APPLICATION NO.	FILING DATE	FIRST NAMED INVENTOR	ATTORNEY DOCKET NO.	CONFIRMATION NO.
10/737,353	12/16/2003	Jennifer Johnson	JJ-645	6003
37282	7590	08/06/2004	EXAMINER	
HOWARD J. GREENWALD P.C. 349 W. COMMERCIAL STREET SUITE 2490 EAST ROCHESTER, NY 14445-2408			COLILLA, DANIEL JAMES	
			ART UNIT	PAPER NUMBER
			2854

Office Action Summary	Application No.		Applicant(s)	
	10/737,353		JOHNSON ET AL.	
	Examiner		Art Unit	
	Dan Colilla		2854

DETAILED ACTION***Drawings***

第 1 図

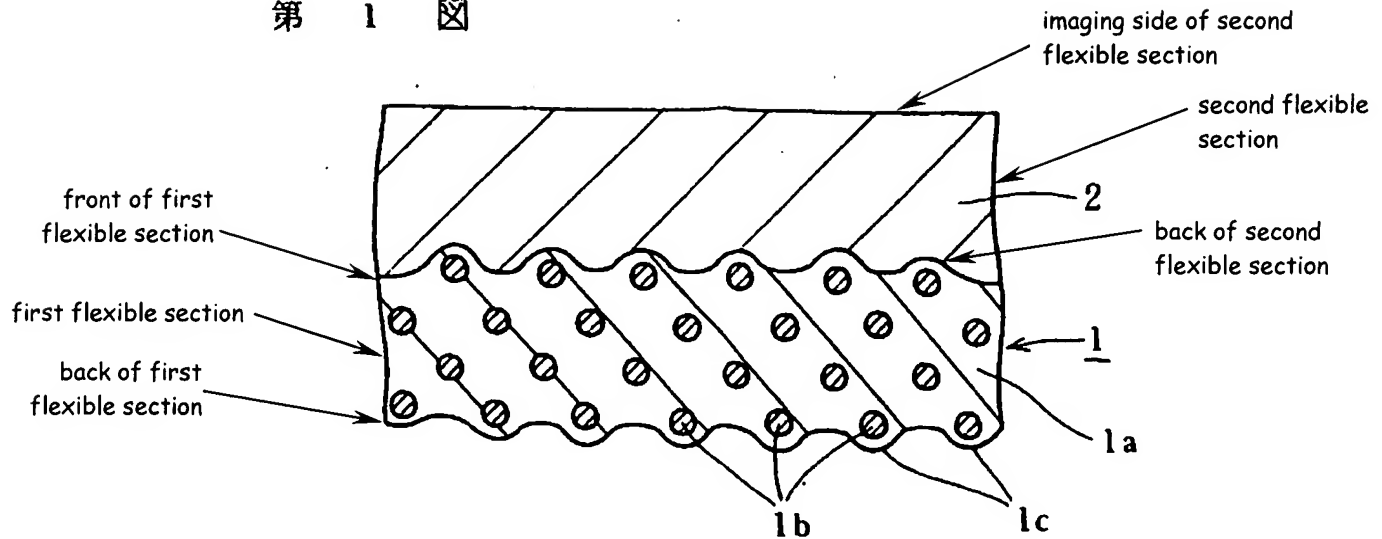
With respect to claim 1, Saito discloses the claimed thermal printing assembly except for the specific Sheffield smoothness and Knoop hardness values and the flexibility of the first section. Saito discloses a thermal printing assembly with a first section 1 having a first front side and a first back side as shown in Figure 1 of Saito. The first section 1 includes a multiplicity of first particles as mentioned in paragraph 1b. While Saito does not disclose specific Sheffield smoothness and Knoop hardness values, these values could have been determined by one of ordinary skill in the art through routine experimentation. It is known that harder materials can undesirably abrade less hard materials and less smooth materials can undesirably catch or create excessive friction when sliding against other materials. Wen et al. teaches a thermal assembly 40 that is flexible as shown in Figure 3 of Wen et al. It would have been obvious to combine the teaching of Wen et al. with the thermal assembly disclosed by Saito for the advantage of conveniently storing the thermal assembly by wrapping it on a spool (US 5,865,548).

With respect to claim 3, Saito et al. teaches an imaging side and a back side of the material 2 such that the back side of material 2 is congruent with the front side of section 1 as shown below in the Figure taken from Saito et al.:

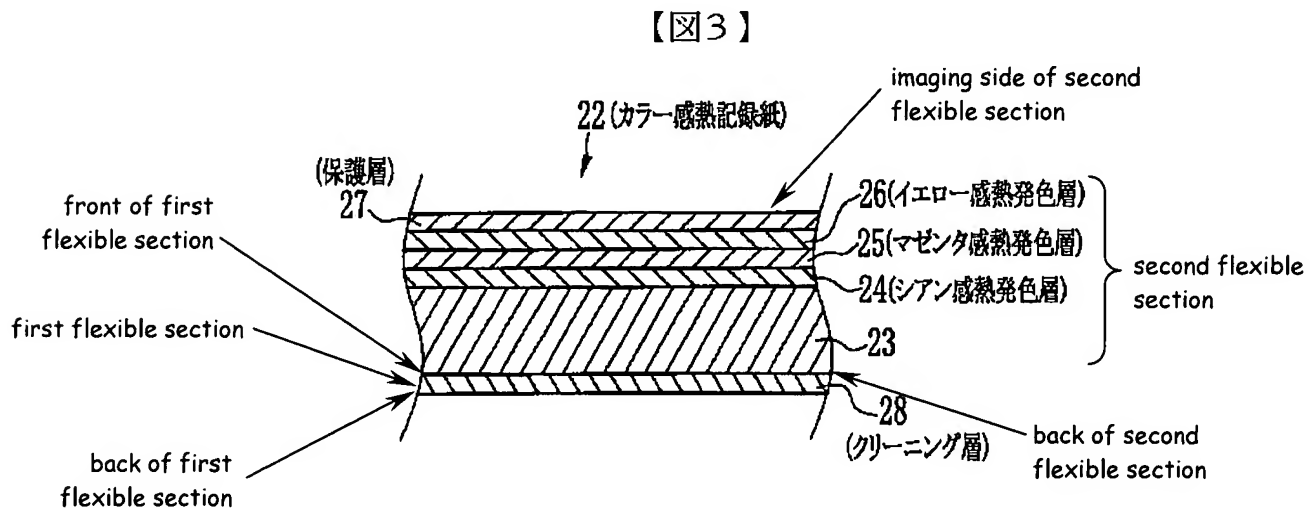
With respect to claim 1, Miyazaki et al. discloses the claimed thermal printing assembly except for the specific Sheffield smoothness and Knoop hardness values. Miyazaki et al. discloses a thermal printing assembly including a first flexible section 28 as shown in Figure 3 of Miyazaki et al. The first section is flexible enough so that it can be fed out of the paper cassette 13 as shown in Figure 1 of Miyazaki et al. The first flexible section 28 includes particles as disclosed in paragraph [0039] of the machine translation of Miyazaki et al. While Miyazaki et al. does not disclose specific Sheffield smoothness and Knoop hardness values, these values could have been determined by one of ordinary skill in the art through routine experimentation. It is known that harder

With respect to claim 2, Miyazaki et al. discloses a second flexible section, layers 23-26, as shown in Figure 3 of Miyazaki et al. These layers form a thermally sensitive media that is a direct thermal sensitive substrate as mentioned in paragraph [0035] of the machine translation of Miyazaki et al.

With respect to claim 4, the thermally sensitive media is a direct thermal sensitive substrate with a first imaging side and a second back side congruent with a first front side of the first flexible section 28 as shown below in the image taken from Figure 3 of Miyazaki et al.:
